Standard Military Pattern (SMP) Vehicles Request For Proposal (RFP)

Solicitation No. W8476-06MSMP/J

Amendment # 012

SCHEDULE BA-7-1- ACCESS LADDER AND STAIR INTERFACE REQUIREMENTS

Figure 1 LADDER INTERFACE

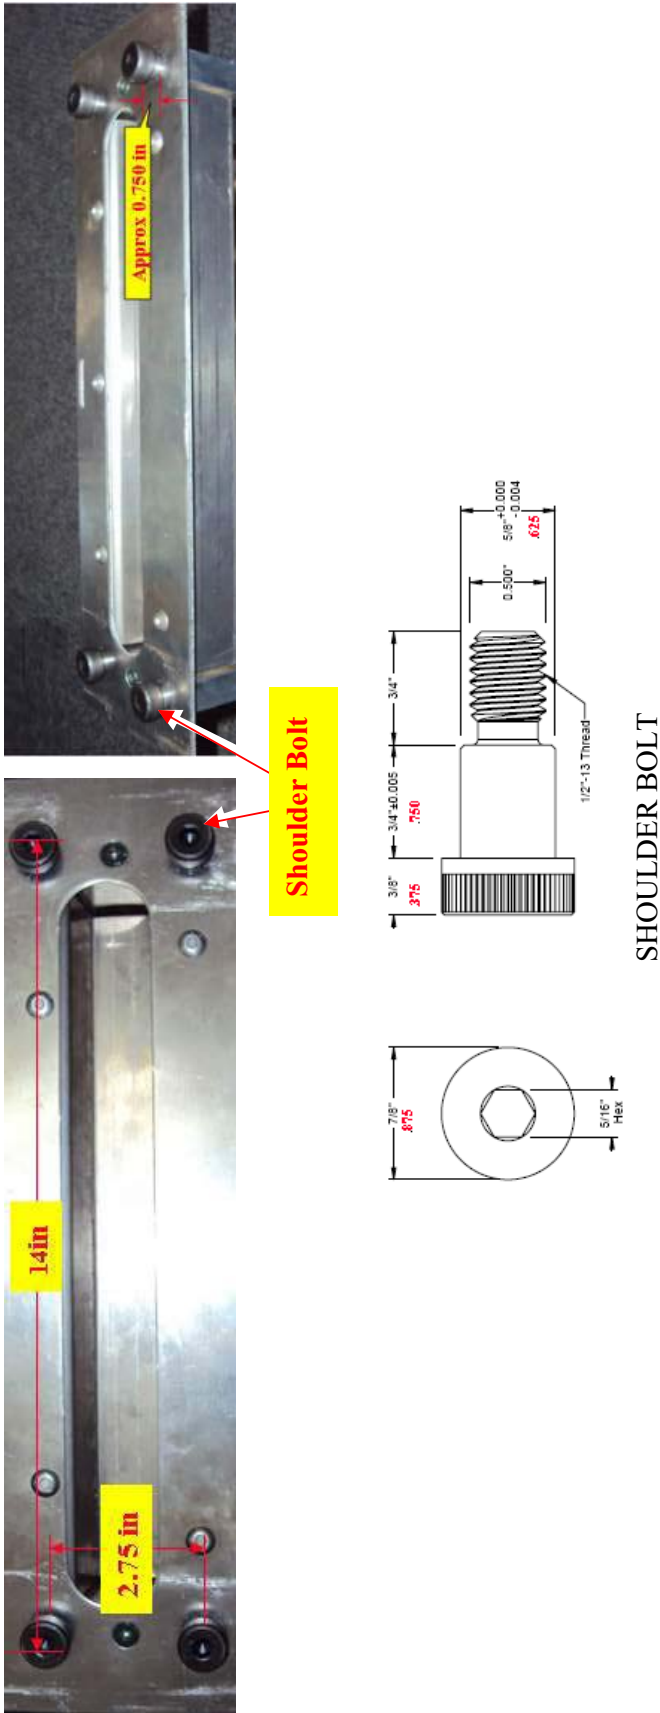
LADDER INTERFACE REQUIREMENTS

- Interface for Access Ladder requires four keyholes
- 2 sets spaced horizontally at 14 inch centers and vertically at 2.75inch centers
 - Key holes need to be sized to accommodate shoulder bolt illustrated

Figure 2 STAIR INTERFACE REQUIREMENTS

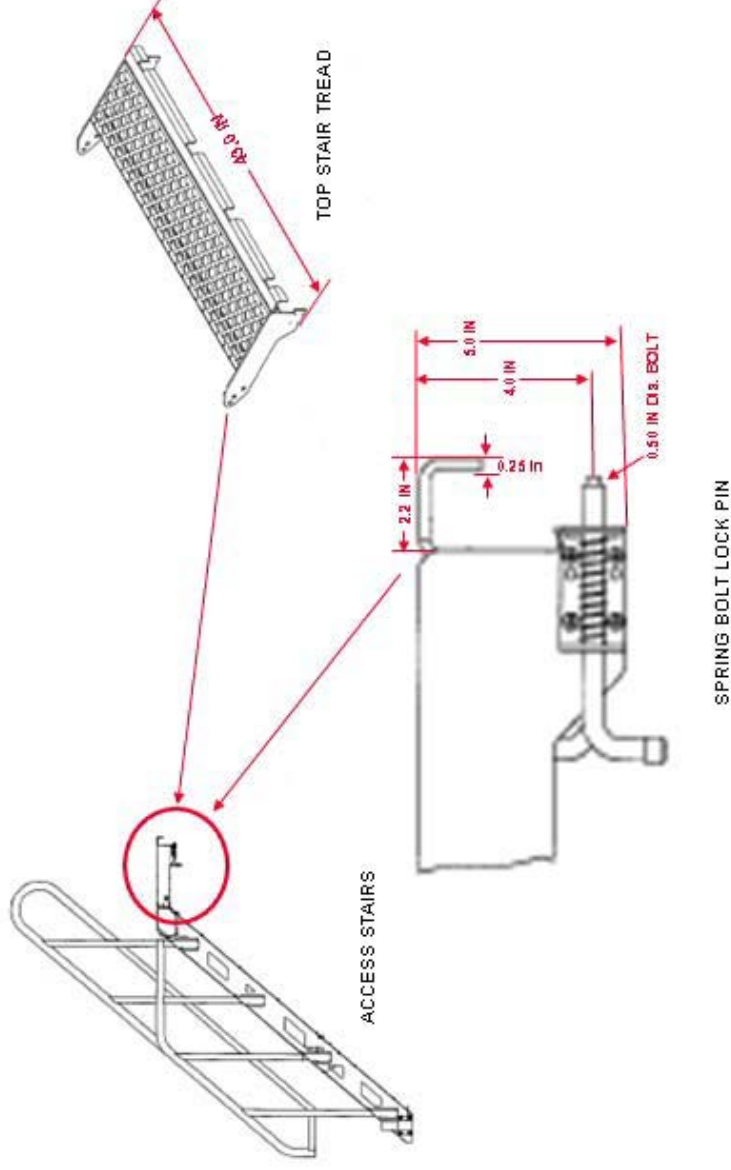
STAIR INTERFACE REQUIREMENTS

Access Stairs are designed to fit over a lipped edge. The mounting hook on the stairs designed to fit over the lipped edge and secured in place with a spring bolt lock.
